CERTIFICATE OF APPROPRIATENESS

Property: 1528 Allston Street, Lot 19, Block 142, Houston Heights Subdivision. The property includes a historic 1,949 square foot house situated on a 6,600 square foot (50' x 132') interior lot.

Proposal: Alteration – Resubmittal: Construct a 1,095 square foot addition to the rear of a 1,949 square foot 1½ story contributing residence.

WEST ELEVATION – FRONT FACING ALLSTON STREET

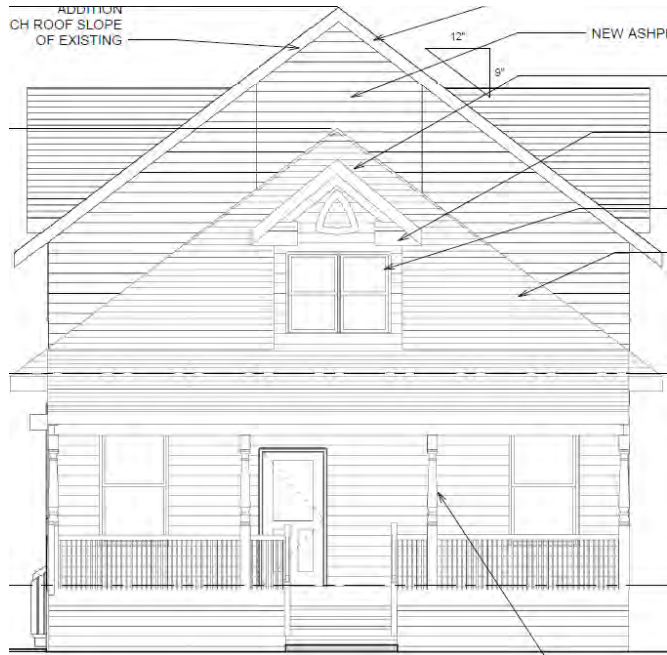
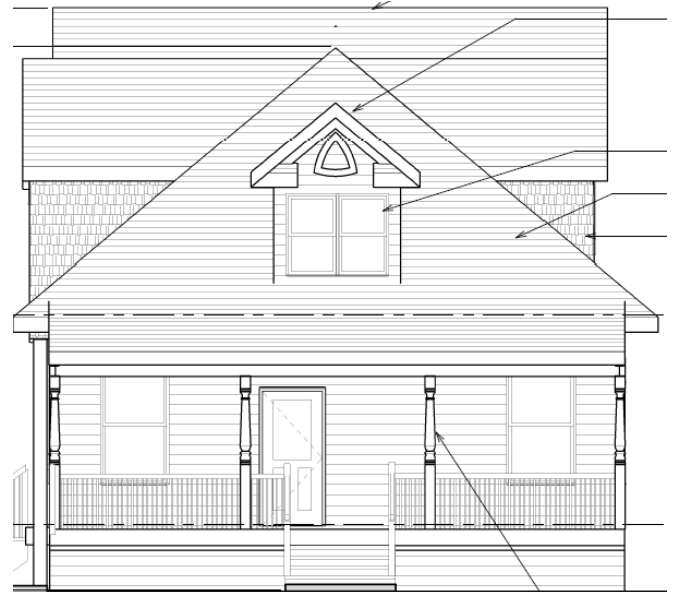
Front Elevation: (West) The front elevation of the existing home will remain unchanged. The addition will begin at the rear wall of the existing home and will feature a front facing gable and no windows.

NORTH SIDE ELEVATION

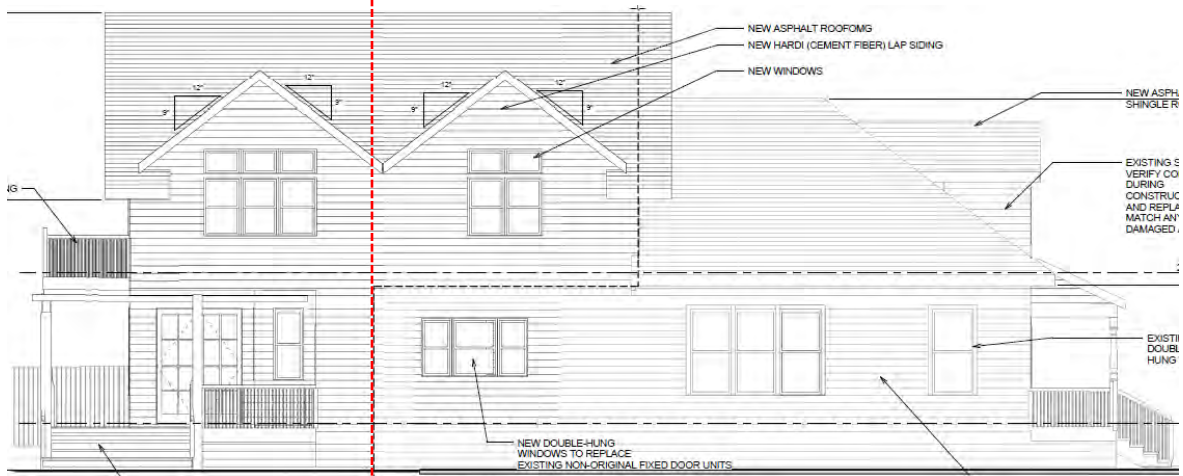
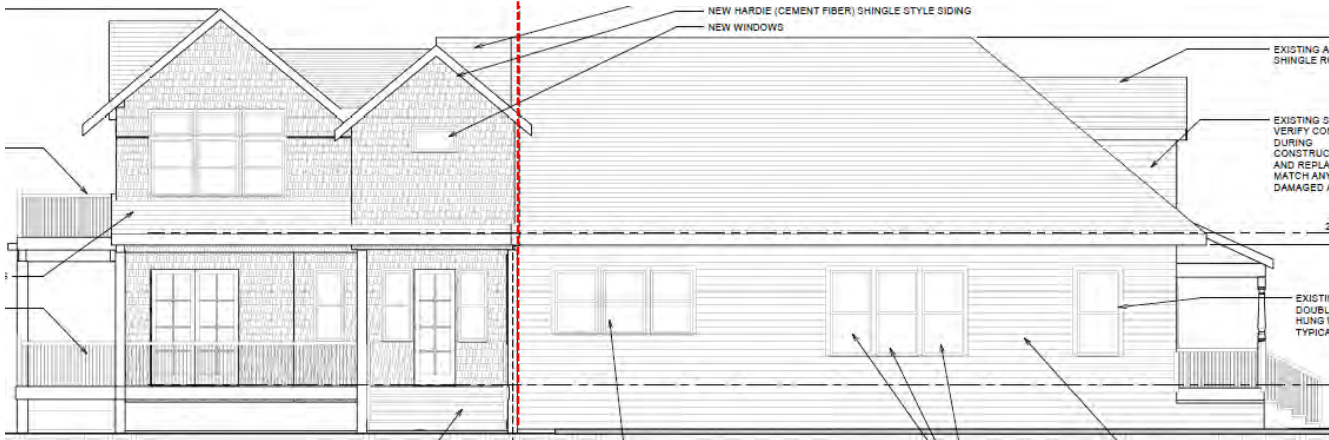
Side Elevation: (North) Replace 4 non-original fixed lite windows and replace with three wood double hung windows. Install a wood double hung window next to a pair of existing historic windows.

The addition will start at the rear wall of the existing home. The north elevation of the addition will feature a pair of gables on second floor and a side/rear facing porch on the first. The second floor gables will feature 5 windows with transom lites.

SOUTH SIDE ELEVATION

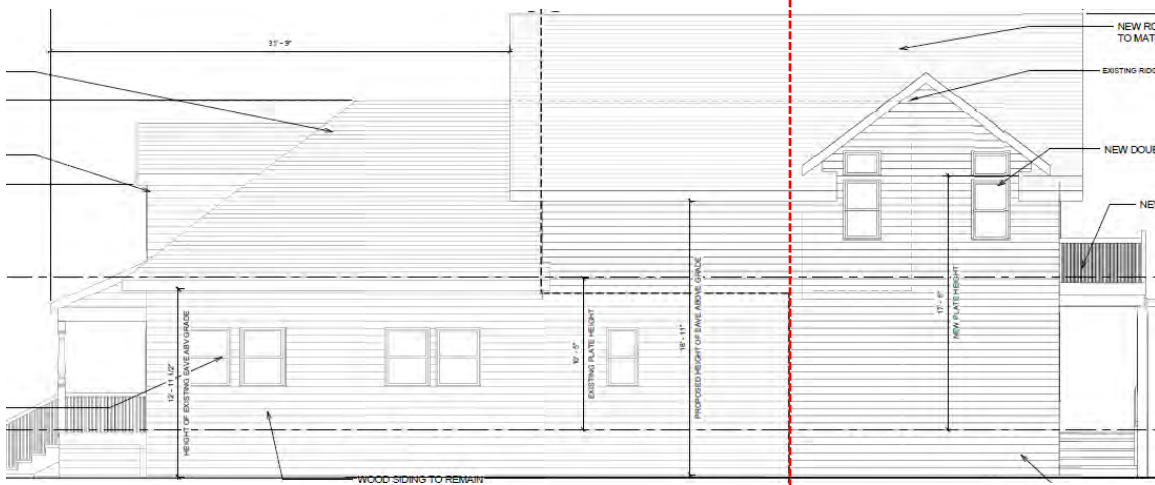
Side Elevation: (South) The addition will start at the rear wall of the existing home. The addition will feature two side facing gables with two windows with transom lites.

SITE PLAN/ROOF PLAN

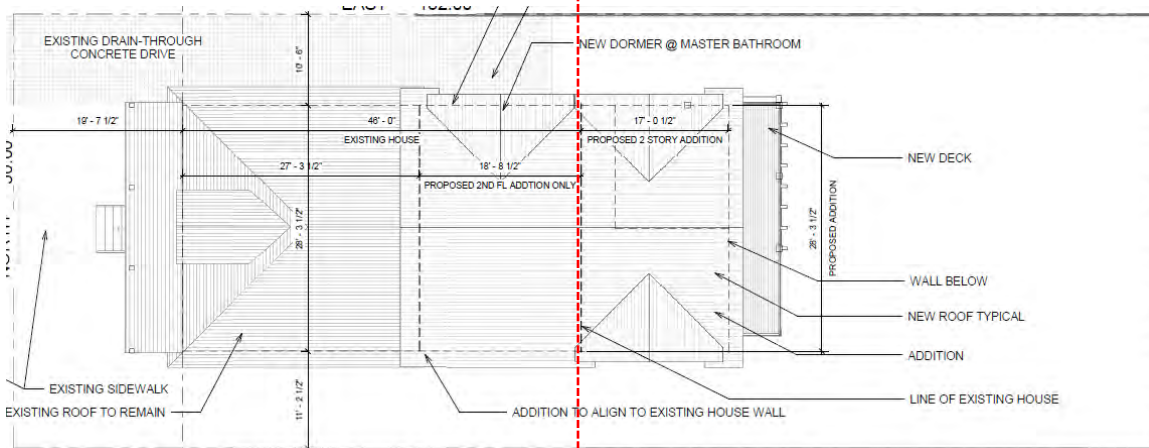
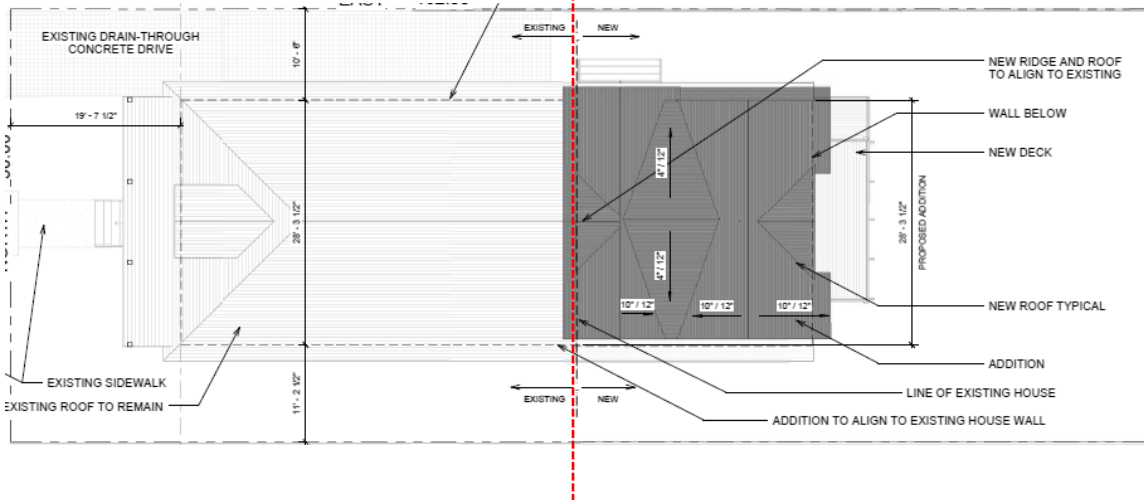
Proposed Revisions: The addition will start at the existing rear wall and add 27' of depth to the existing structure. The addition will be inset by 2' along the north facing wall.
